Draft submission to, amendments to SEPP (Western Sydney Aerotropolis) 2020, Open Space Needs Study, draft Aerotropolis Development Control Plan - Phase 2 and Luddenham Village Discussion Paper

Proposed amendments to SEPP (Western Sydney Aerotropolis) 2020

Draft Aerotropolis Development Control Plan Phase 2

Map 1 Undevelopable Parcels due to location of Stormwater Infrastructure

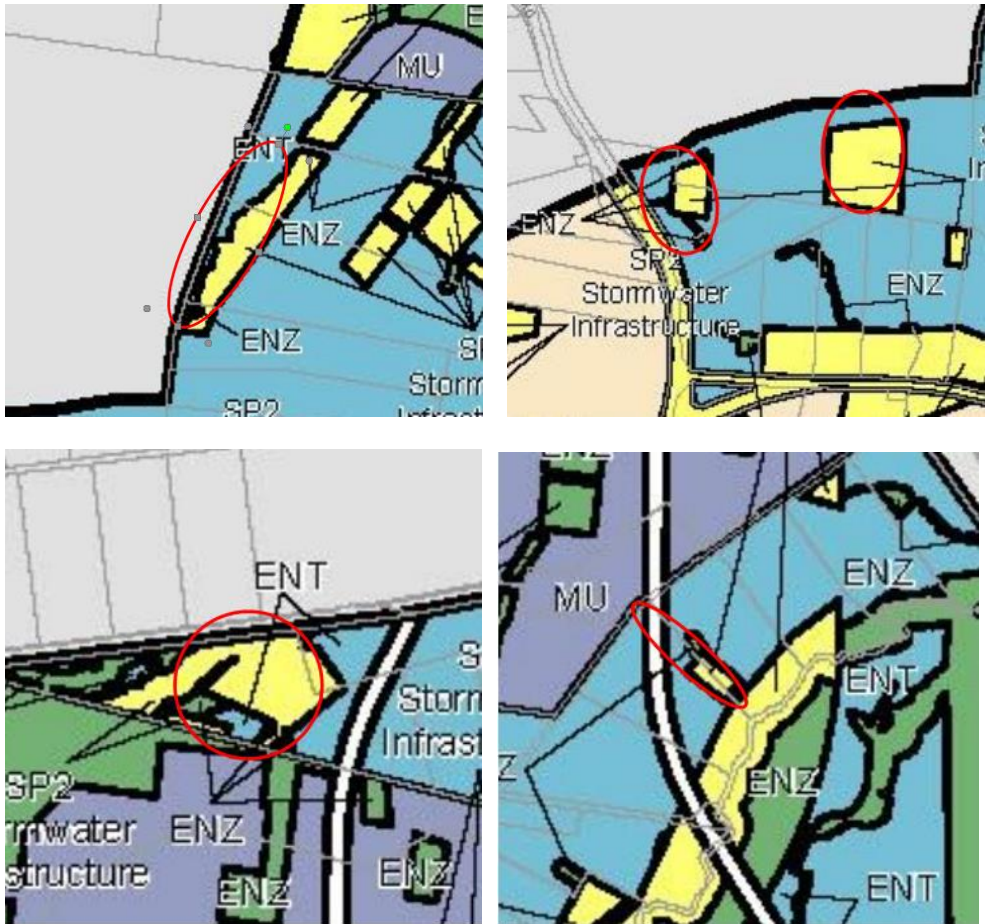
Due to the revision of the open space network, there are several parcels of land in the Northern Gateway Precinct that were previously identified as open space in the Aerotropolis Precinct Plan, and that are zoned Enterprise, that do not meet the minimum block size control of 150m x 150m of the Aerotropolis Precinct Plan due to the location of stormwater infrastructure and rendering these properties not being able to be developed.

The following map highlights the parcels that cannot be developed and the adjoining SP2 Stormwater Infrastructure Zone and the Land Reservation Acquisition affectation should also apply to these parcels of lands.

Land management of these parcels of land will be an issue if they remain in private ownership.

Map 2 Parcels of Enterprise zoned land isolated by the Outer Sydney Orbital

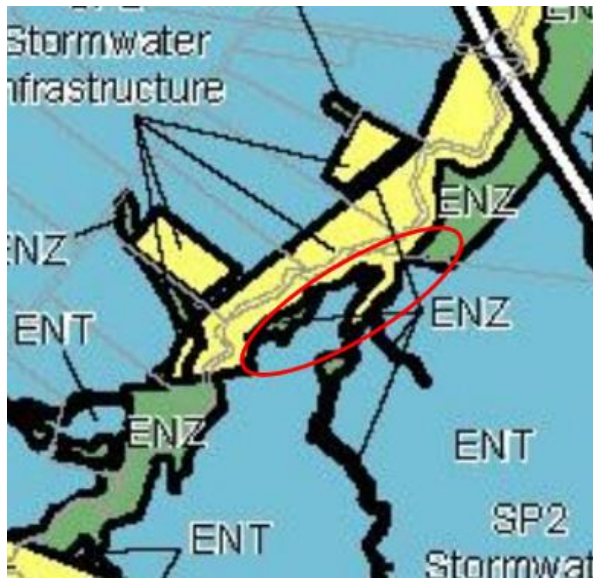
There are also a couple of parcels of land that were previously identified as open space in the Precinct Plan that also appear to be undevelopable as they are isolated by the Outer Sydney Orbital Corridor and constrained by adjoining SP Stormwater Infrastructure zone or Environment and Recreation zone.

Unless these parcels of land are to be acquired as part of the Outer Sydney Orbital, these parcels should also be identified for acquisition as they are unable to be developed.
